STATE OF NORTH CAROLINA  
DEPARTMENT OF TRANSPORTATION

July 27, 2011

SUBJECT: **Supplemental Information for Application for Section 404 Individual Permit and Section 401 Individual Water Quality Certification** for the proposed widening of R-2413C - US 220 south of the Haw River to the Intersection of US 220 and existing NC 68 in Guilford and Rockingham Counties, Division 7. State Project No. 6499008T, WBS Element No. 34429.1.1.

SITE 8

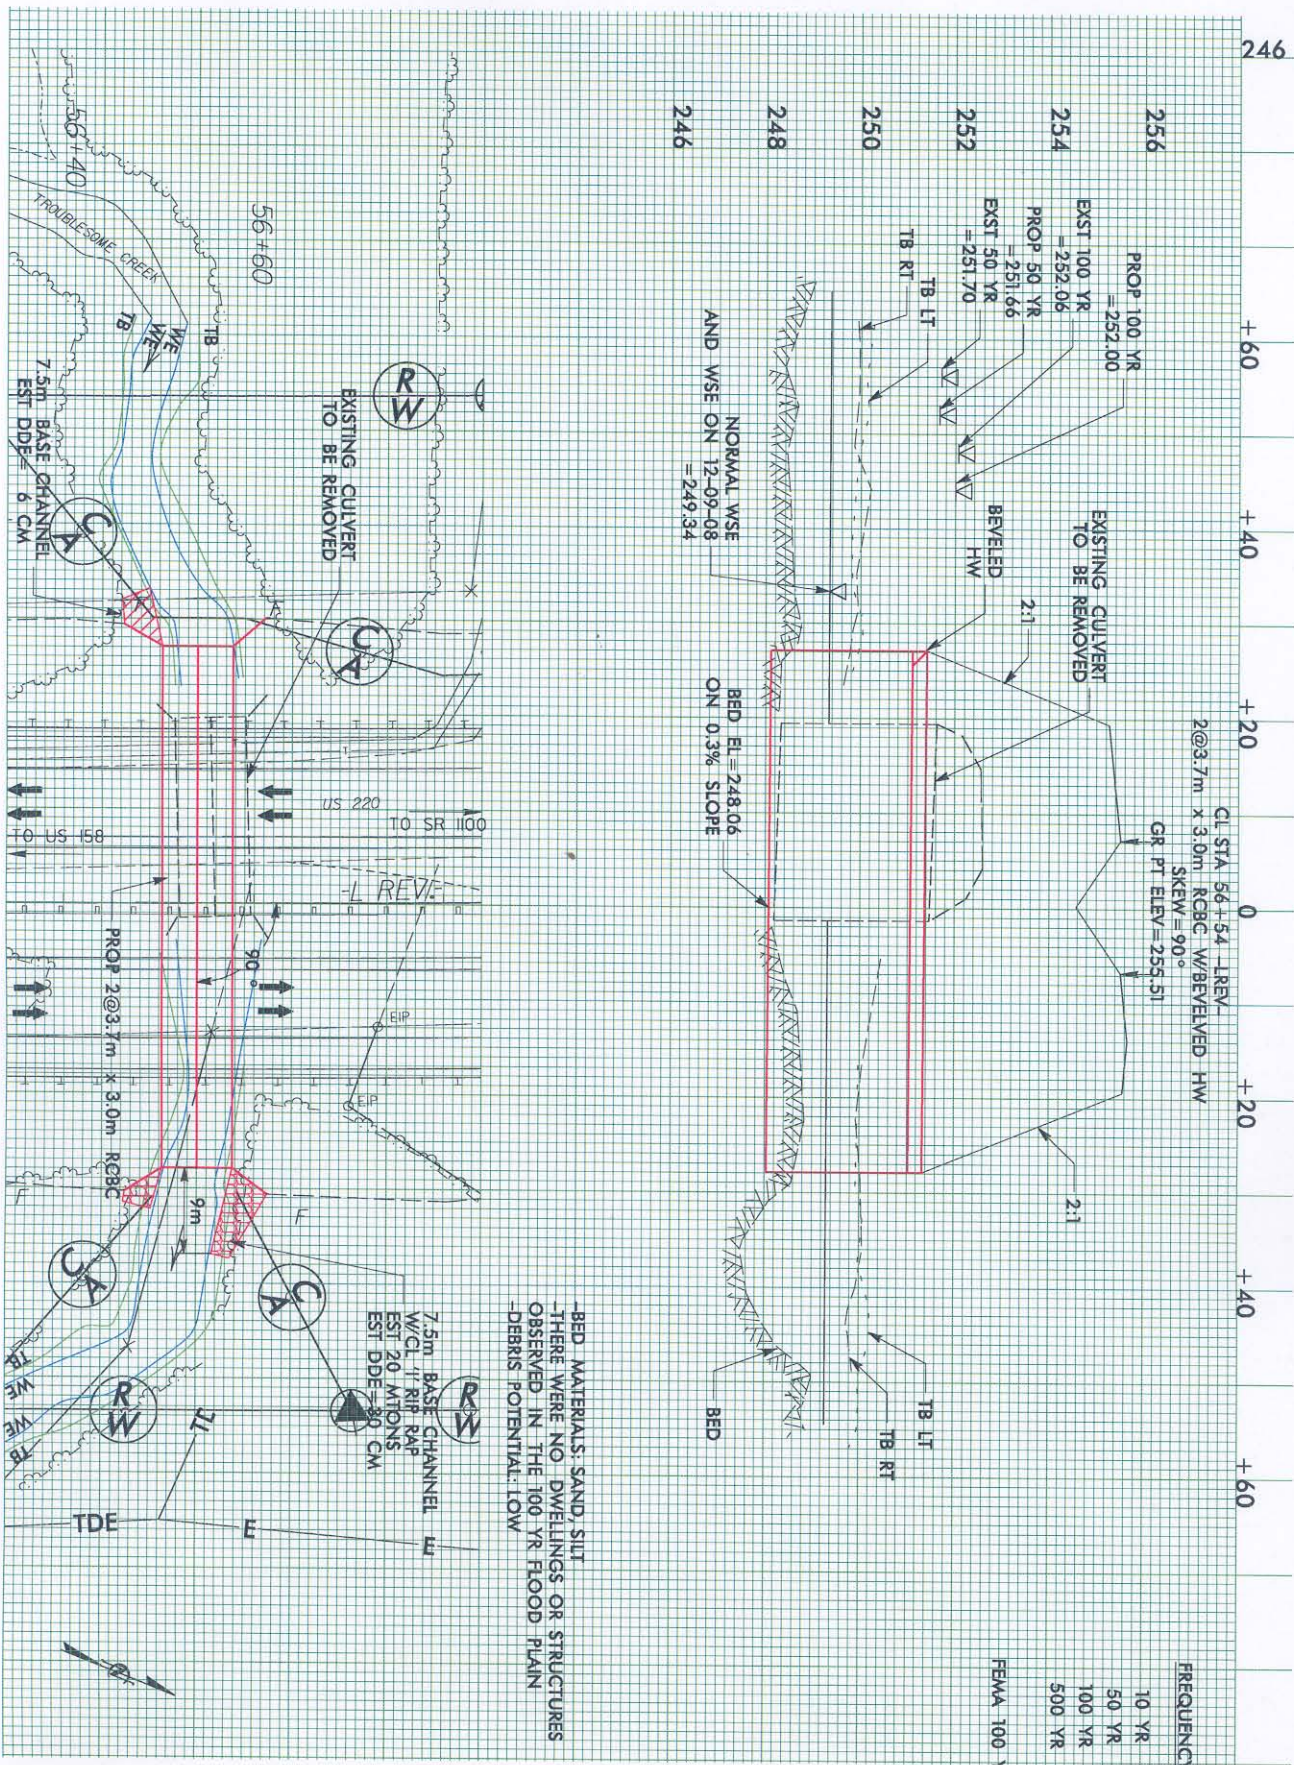
Site 8: I visited the site. At the culvert inlet and outlet, the channel width bumps out. If you go downstream of the existing culvert, the channel appears to narrow up to the width of a single barrel. Not installing a sill and restricting low flow into one barrel will result in the outlet of the extended culvert over widening. Please ask hydro to look at this in more detail.

*In the vicinity of the culvert, the field surveyed stream width is approximately the width of the proposed culvert. The water's edge lines nearly match the culvert at the inlet and outlet. See the attached Site 8 drawing that shows our surveyed water's edge lines (in blue). This appears to be beyond the limits of the channel widening due to the existing culvert. Also, the normal water depth in this culvert is nearly 3 feet deep, so adding a sill would block nearly a third of one barrel.*

**PRELIMINARY PLANS**  
DO NOT USE FOR CONSTRUCTION  
Permit Drawing  
Sheet 14 of 40  
REVISED  
5/12/01

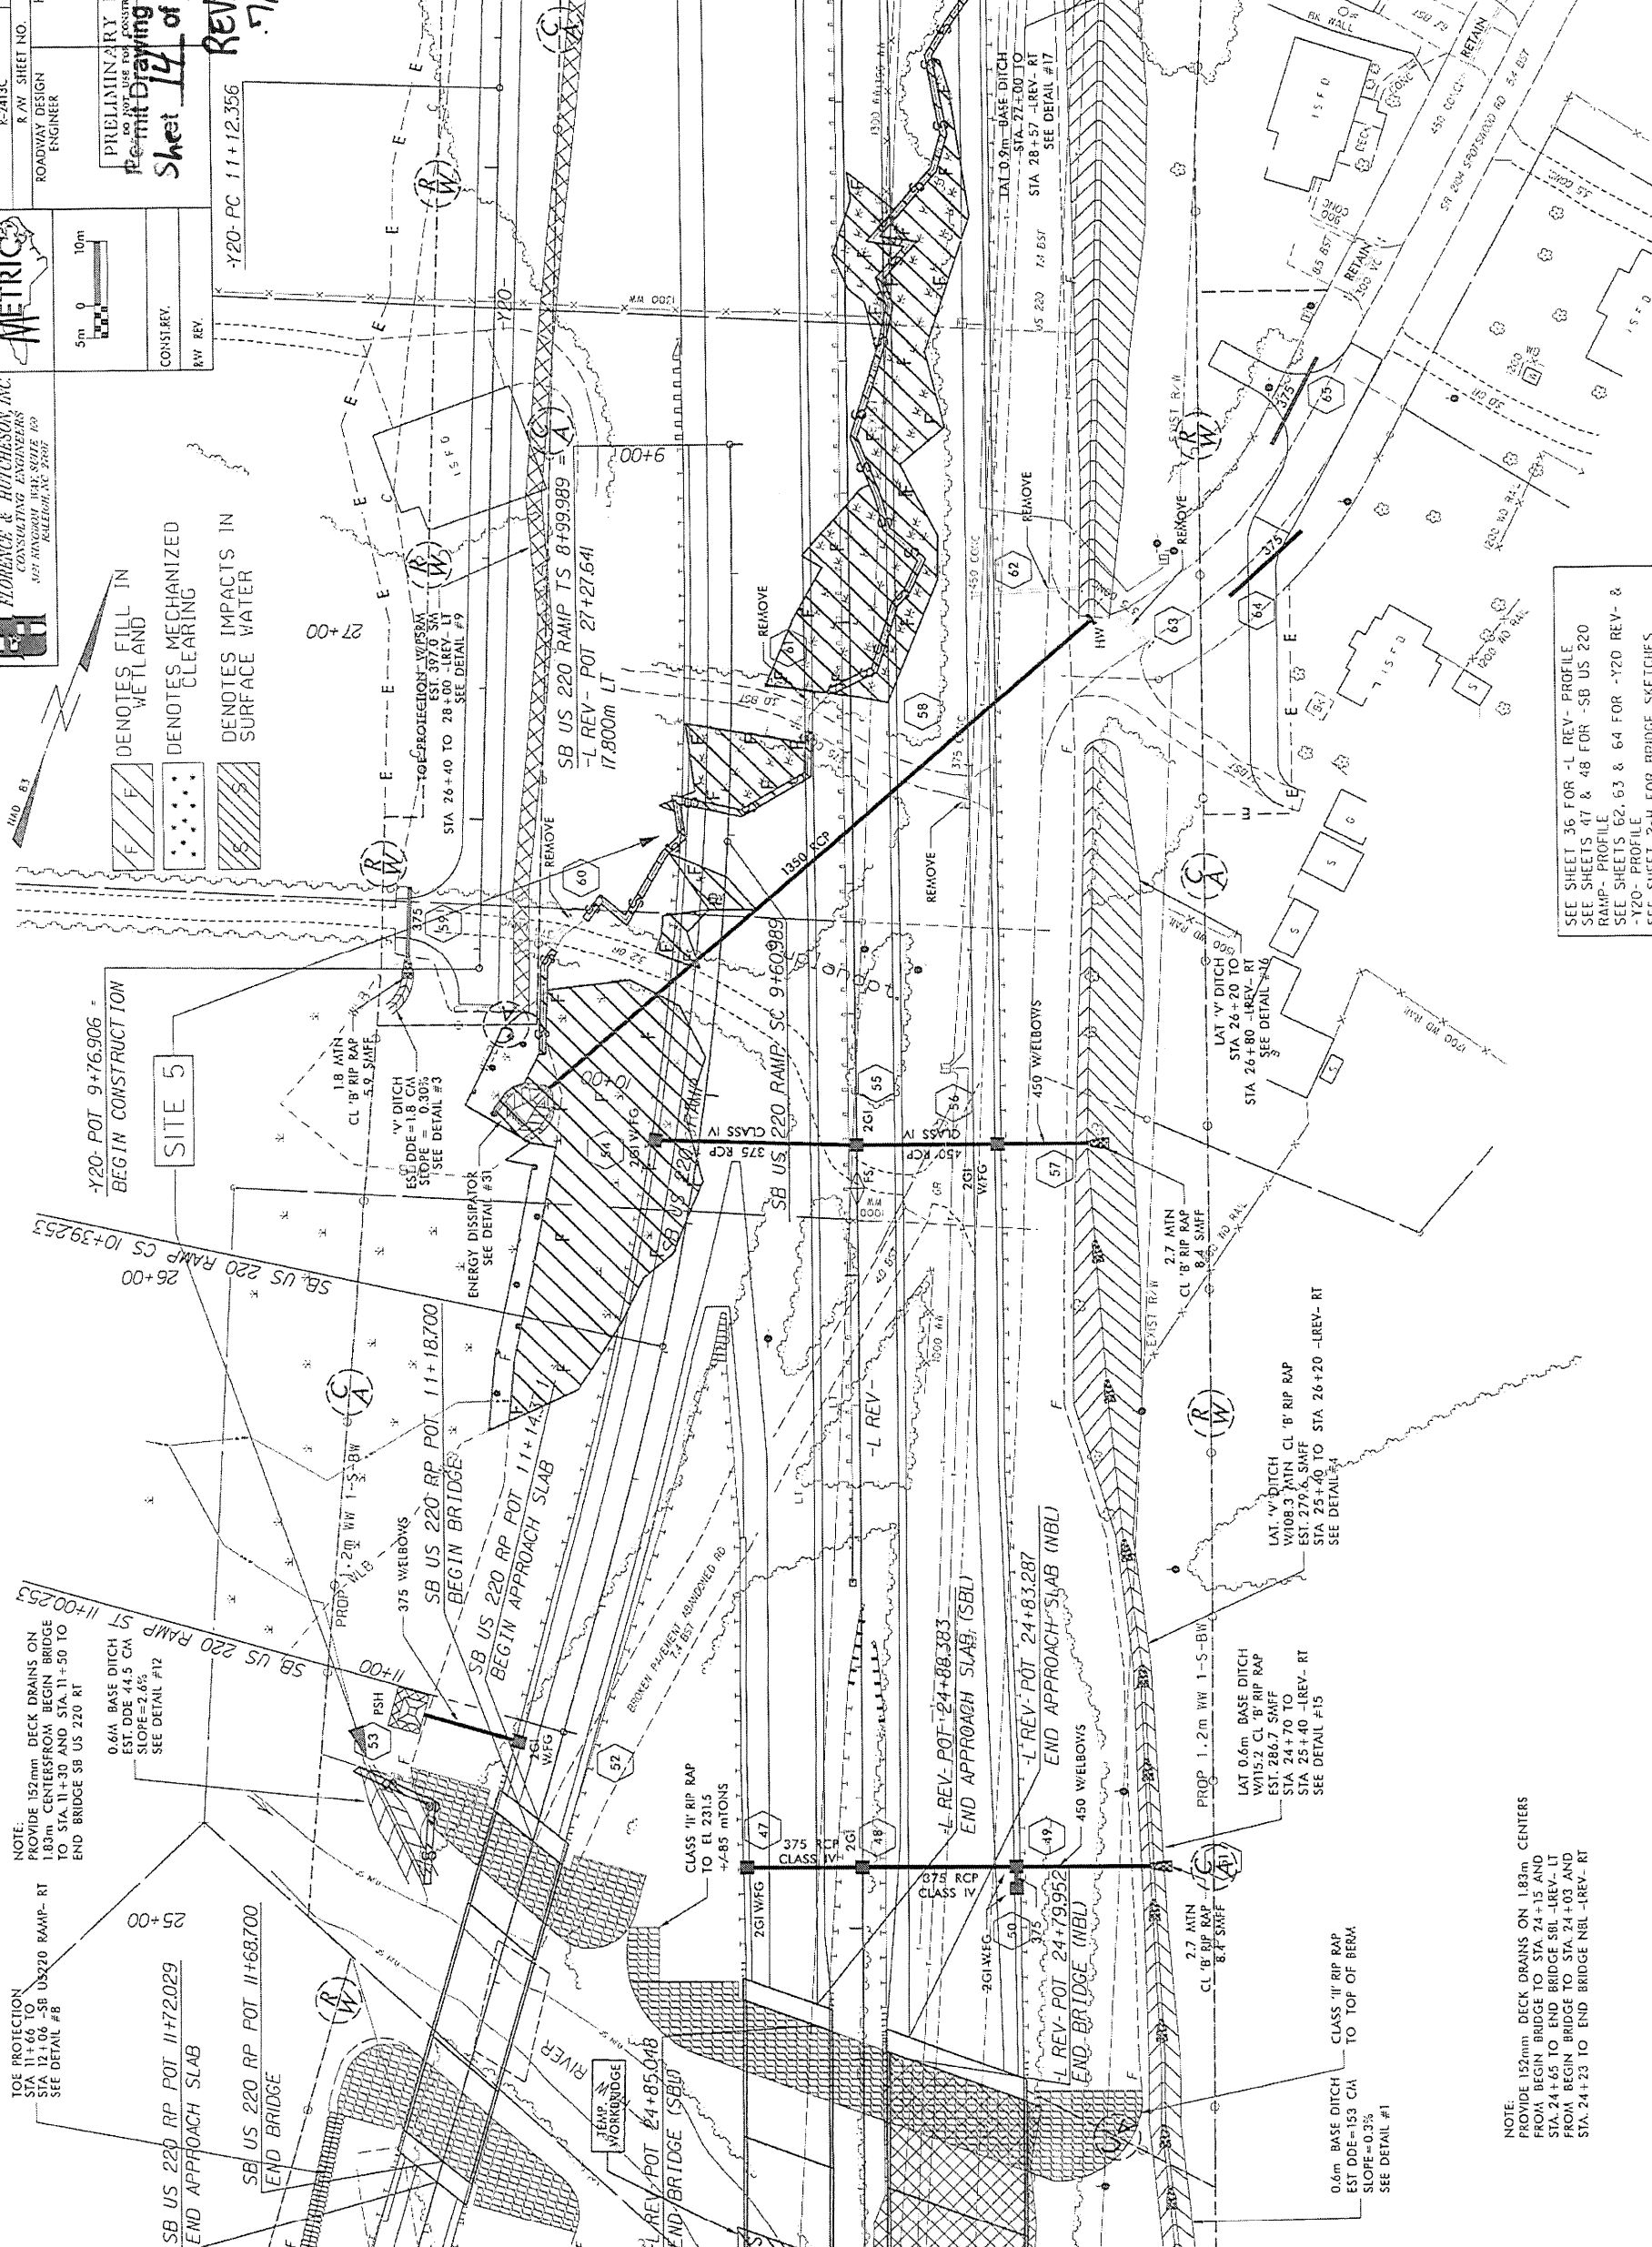
Sta 11+00 SB 220 on revised permit drawing Sheet 14 of 40 and plan Sheet 7 (see attached)

*NCDOT: A PFSH has been added at this location.*

Permit Drawing  
Sheet 18 of 40  
REVISED  
7/20/11

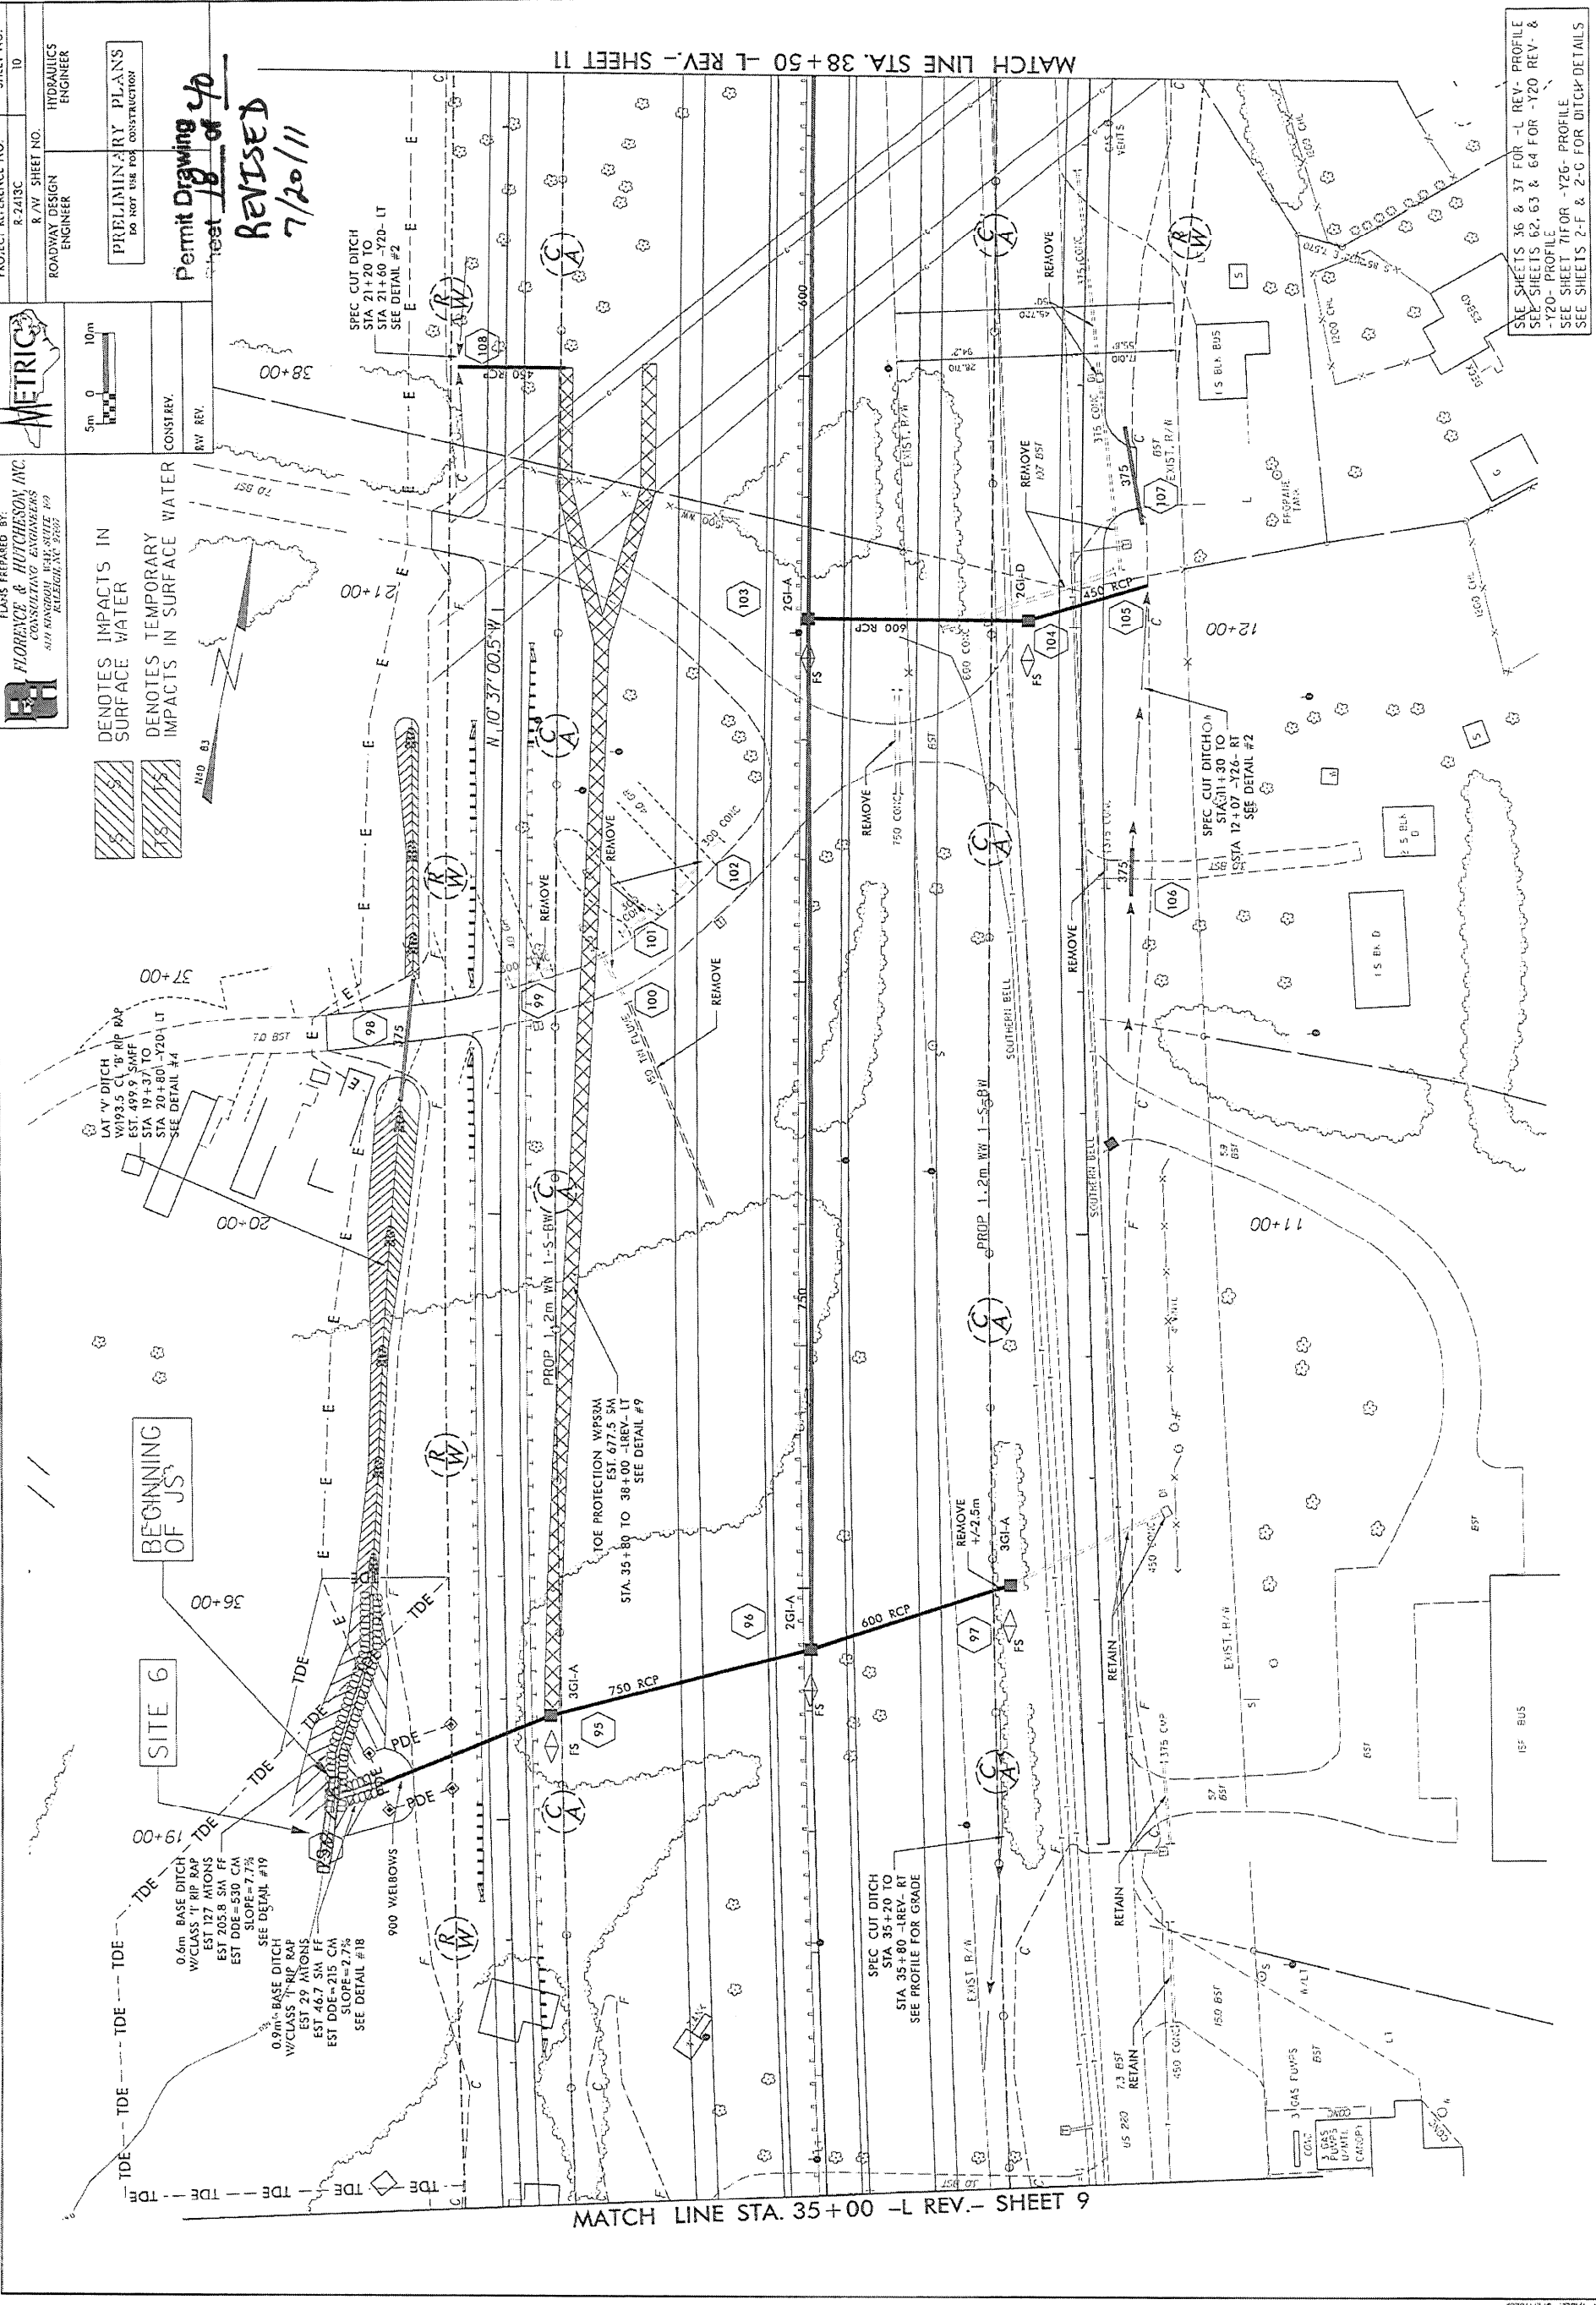
Sta 29+00 on revised permit drawing Sheet 18 of 40 and plan Sheet 10 (see attached)

I'm working on the impact tables, and I noticed that temporary impacts have not been included for most of the permitted sites on R2413C. Can you make sure this is right? I'm not sure how they will dewater without temporary impacts.

*NCDOT: This outlet does not meet the requirements for a PFSH since it is a 24-inch pipe. A special cut ditch was added north of Site 6.*

*Site 6: Sheet 18 of 40*
